**UNITED STATES ENVIRONMENTAL PROTECTION AGENCY
REGION 8**

Subject: 2010 Revisions to the Basic Standards and
Methodologies for Surface Waters

**ENCLOSURE 1:
RATIONALE FOR THE U.S. EPA REGION 8 PARTIAL ACTION ON REVISIONS TO THE
BASIC STANDARDS AND METHODOLOGIES FOR SURFACE WATERS**

Figure 1: Comparison of the revised hardness-dependent acute criteria to existing table value standards (EPA 304(a) criterion = 750 µg/L) and empirical acute toxicity data presented by Colorado Mining Association.

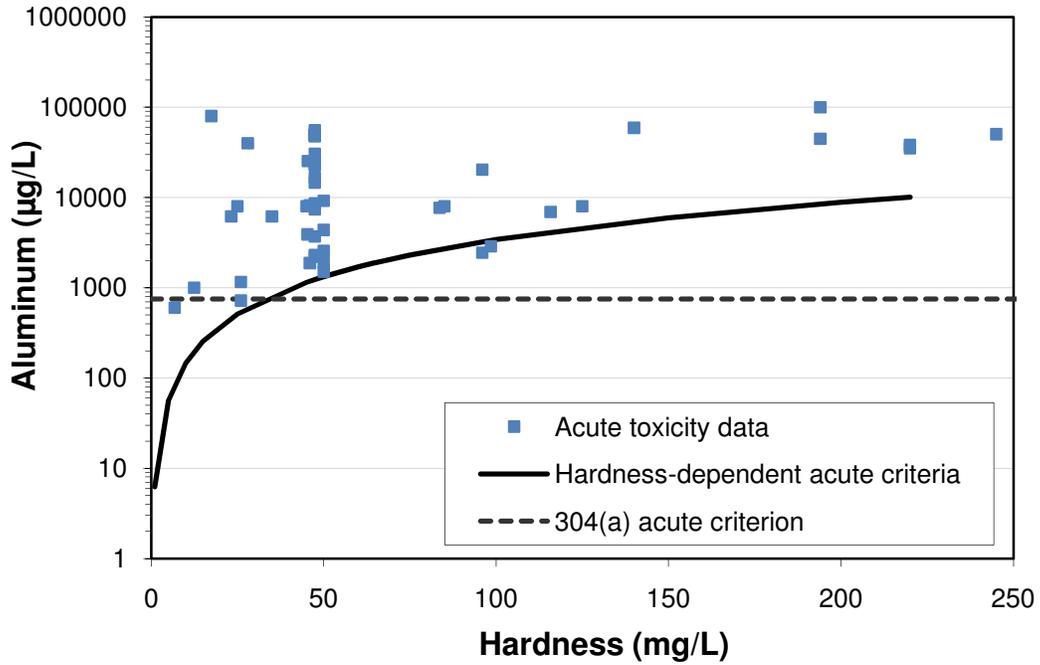
Although the revised table value standards for aluminum are substantially different from CWA§ 304(a) recommendations for aluminum, EPA agrees that the revised standards are scientifically defensible and protective of aquatic life. EPA took the following information into consideration when evaluating the protectiveness of the criterion.

Based on review of the information submitted by the Division and the Colorado Mining Association, EPA concludes that the revisions to the aluminum table value standards protect the aquatic life use and are based on sound scientific rationale (40 CFR Section 131.11(a)(1)). Accordingly, the revisions are approved, subject to ESA consultation.

Figure 2: Comparison of the revised hardness-dependent chronic criteria to existing table value standards (EPA 304(a) criterion = 87 µg/L) and empirical chronic toxicity data presented by Colorado Mining Association. Existing table value standards apply when pH is < 7.0 or hardness is < 50 mg/L.

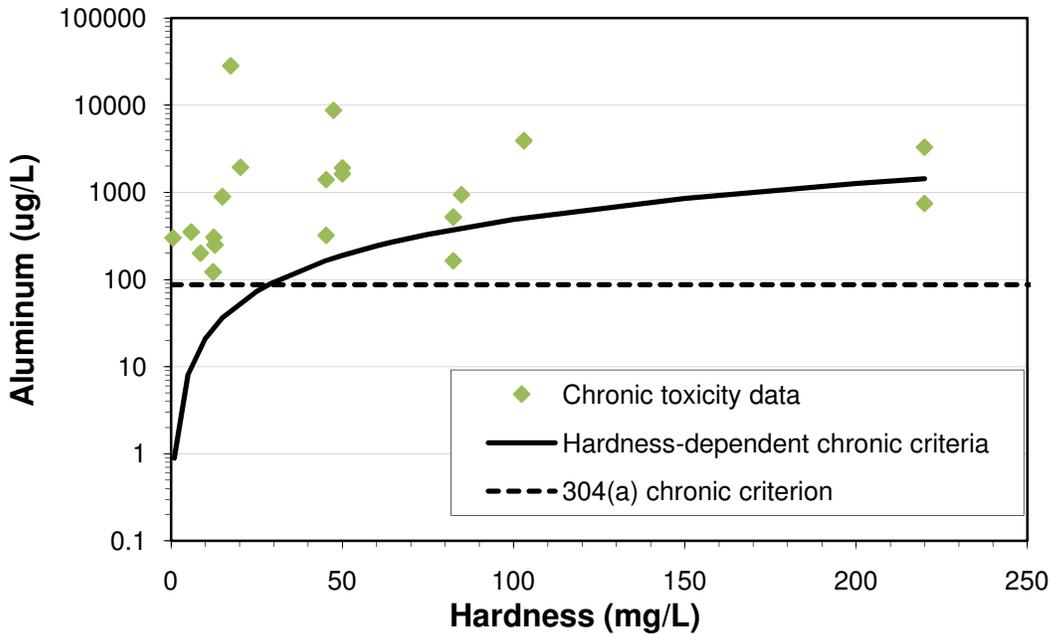
less than 7.0 and hardness is greater than 29 mg/L, and less stringent than the CWA § 304(a) chronic criterion when pH is greater than 7.0 and hardness is greater than 29 mg/L (Figure 2). The revised table values include a chronic criterion when hardness is equal to or greater than 50 mg/L and pH is equal to or greater than 7.0. Prior to this revision, under the previous footnote 11, no chronic criterion applied under these water quality conditions.

- The revised chronic criteria provide better protection for aquatic life since it is applicable to all waterbodies, rather than just waterbodies where hardness is less than 50 mg/L or pH less than 7.0.

- The revised Footnote 11 continues to recognize that aluminum toxicity increases at low pH by requiring that a chronic criterion equal to or more stringent than the CWA § 304(a) chronic criterion of 87 µg/L shall apply when pH is < 7.0.
